Addendum – Pedestrian & Cyclist bridge Environmental Assessment Report

September | 2023

Iarnród Éireann
Irish Rail

Figure 1 - Parapet Design Representation 1

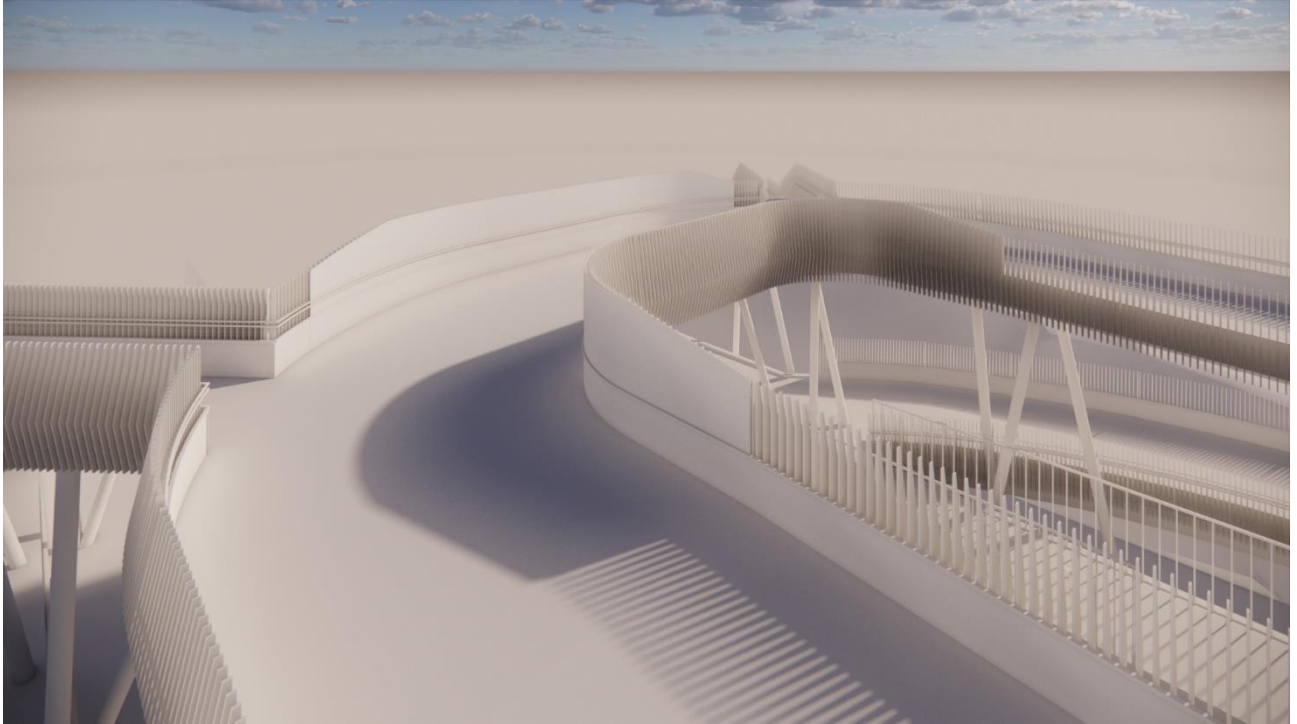
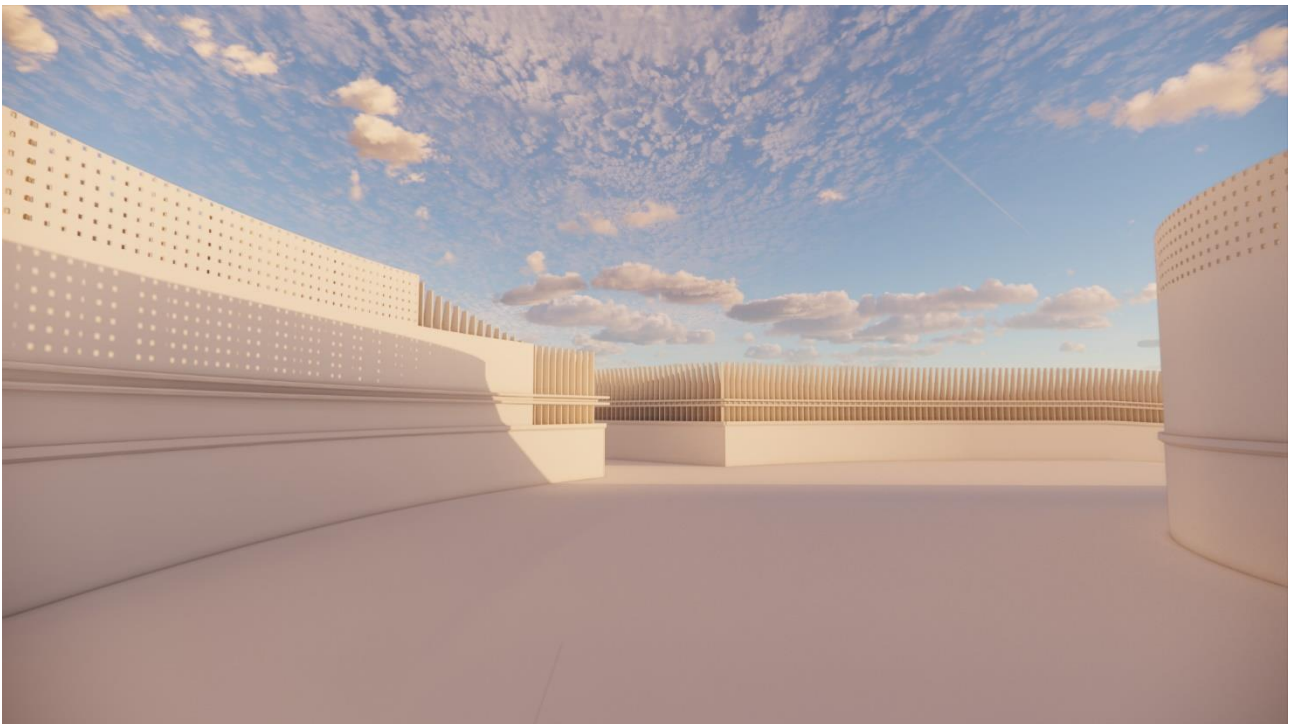
The proposal consists of the same steel structure bridge proposed in the draft RO, reducing the bridge clearance from the original 6.55 m to 5.30 m and reducing the length of the ramp. The bridge design includes:

- 5.30m bridge clearance from TOR. (19% of reduction in bridge height)
- The proposed bridge length is 329 m, reducing 58 m from the draft RO design length (387m).
- 2 lifts incorporated (one on either side of rail)
- Slight amendments to stair access
- Improve transparency on parapets.

Figure 1 and **Figure 2** below are visual representations of how the design development to the parapets will look in the permanent situation.

Figure 4 Clonsilla footbridge proposal. No damming and dewatering of the Canal is required.

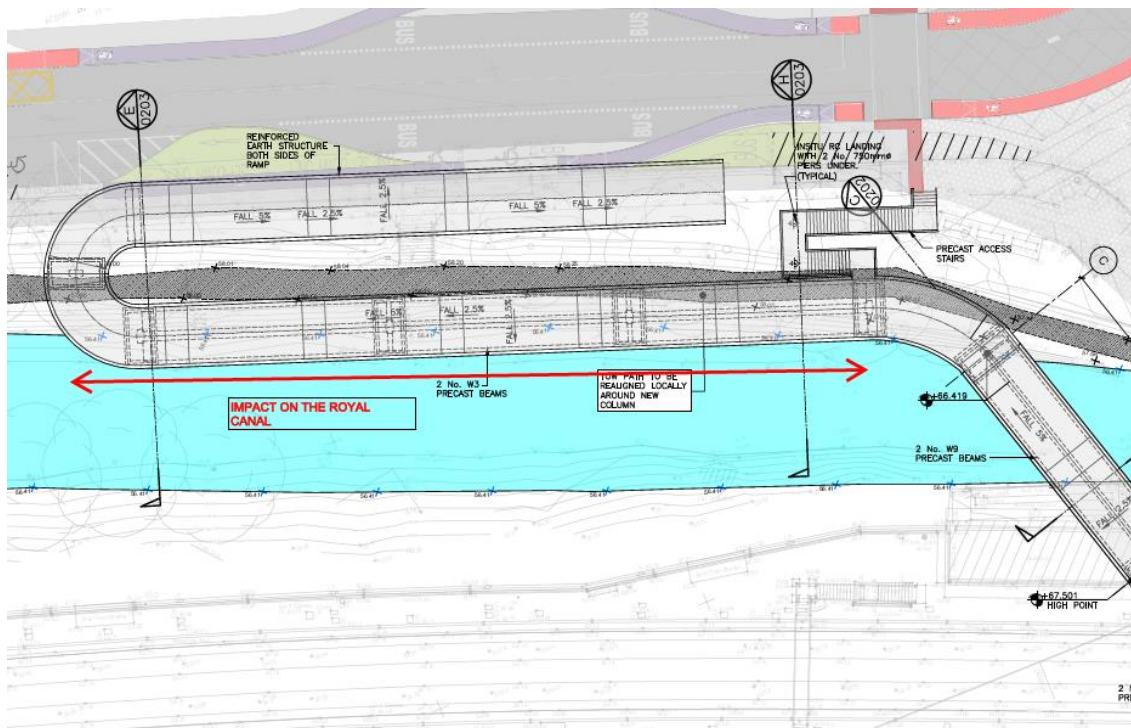
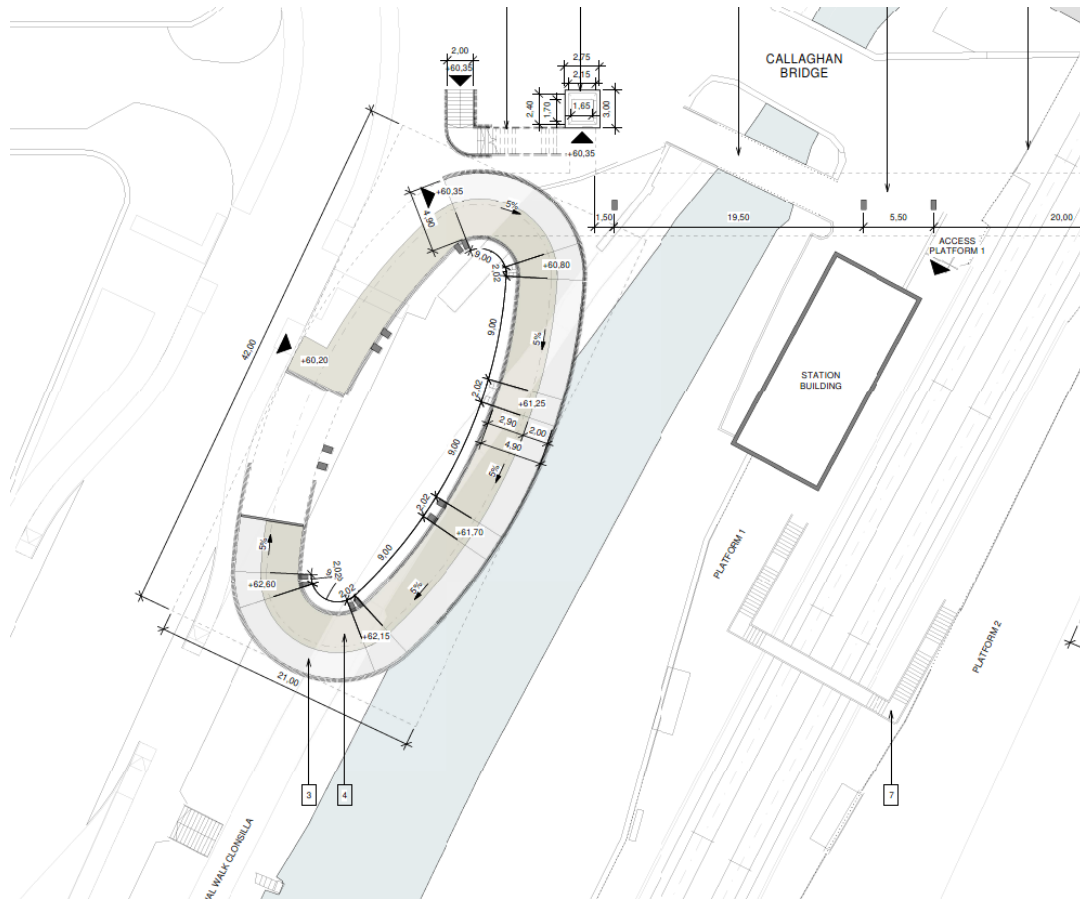
Note that the new proposal reduces the impact on the Royal Canal, reducing both the length of the walkway that is over the Canal on the north side, from 50 m to 30 m, and the number of foundations that are located on the edge of the Canal are also reduced from 4 to 2.

In the case of the Clonsilla footbridge, the draft RO design required damming and dewatering of the Canal to install foundations under the piers at the north approach ramp. Temporary works in and around the Canal were undertaken to enable the piling.

- **Figure 3 Draft RO design with 4 piles impacting the Royal Canal. Damming and dewatering the Canal are required.**

The proposal does not require damming and dewatering of the Canal but it still needs works around the Canal.
